Subject: 10CFR21 Reporting of Defects and Non-Compliance -
Engine Systems, Inc. Report No. 10CFR21-0084, Rev. 0

Norgren R18 relieving style pressure regulating valves

10CFR21 REPORTING OF DEFECTS AND NON-COMPLIANCE

COMPONENT: Air Start System Pressure Reducing Valve, Norgren R1& Relieving

FIGURE 2
Valve Position during event

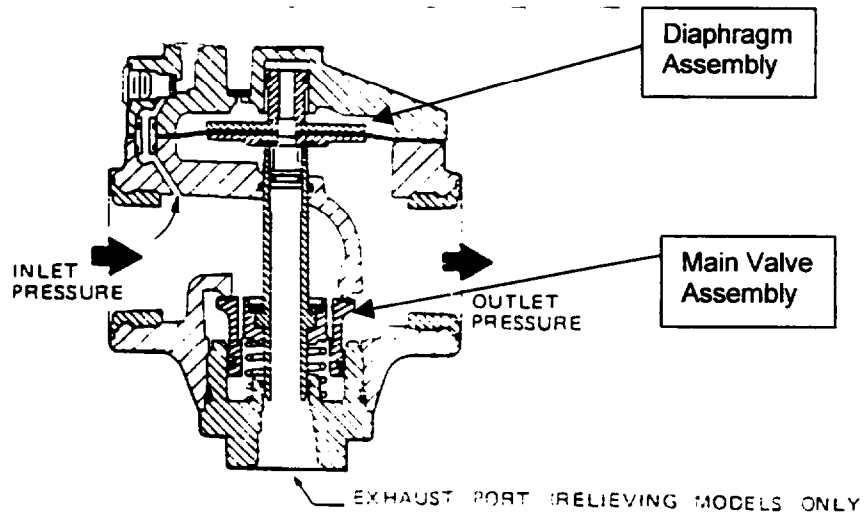
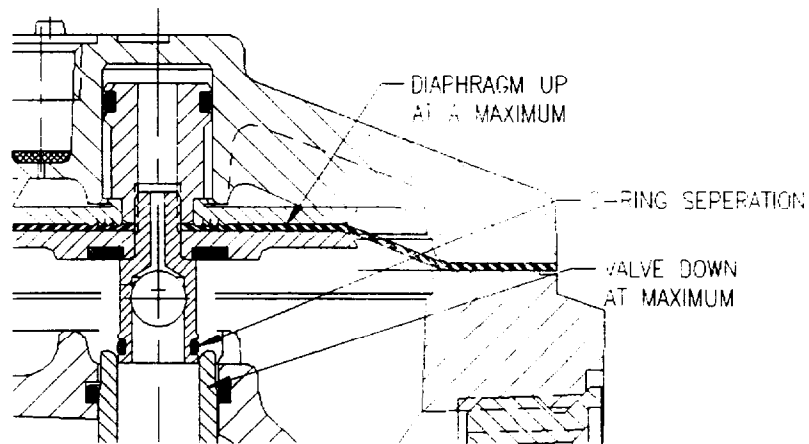
C.A. Norgren Company, the manufacturer of the valve, was contacted to evaluate the condition and assist in a resolution. After evaluating the problem Norgren determined that the sudden demand in flow during an engine start caused the main valve to open further than is normally expected. When the air flow is suddenly terminated following the engine start, the resulting backpressure within the valve causes the diaphragm assembly to travel to its maximum upper position and allows its o-ring to separate from the valve tube. The relative positions of the two components causes the main valve to stick in the open position and opens the air relief path through the relieving tube of the regulator. The o-rings around the relief tube and on the diaphragm retainer in addition to the forces generated by the flow through the valve contribute to hold the valve open. As the pressure in the air receiver falls, the forces acting to hold the valve open decrease and the valve returns to its closed position. Refer to figures 1 & 2.

The first change is to a sub-component of the diaphragm assembly. As seen in Figure 2 the retainer has become separated from the relief tube during sudden backpressure situations causing a resistance to the relief tube returning to the neutral position at no flow. The retainer was extended to ensure the tube cannot come free when the valve and diaphragm are at their furthest separation. Refer to figure 3 depicting the extended retainer installed.

FIGURE 4
Retainer O-Ring in tube

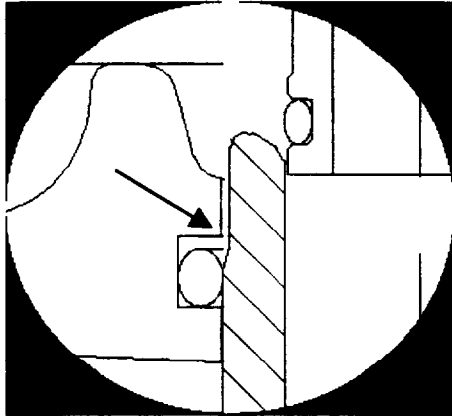
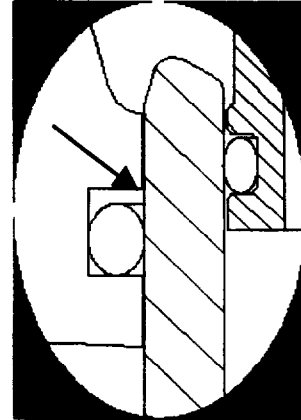
The second change is to the valve tube. As seen in Figure 4, when the valve is open at a maximum, there is room for the o-ring to start extruding from the cavity. When the relief tube tries to return to its normal position, the o-ring provides resistance. The geometry of the valve tube at the o-ring interface was modified to eliminate the smaller diameter on the tube to prevent the o-ring from extruding. Refer to figure 5.

Replace the valve/tube assembly and diaphragm assembly. The part number for the re-designed valve/tube assembly is 5945-60. The part number for the diaphragm assembly is 5945-61.
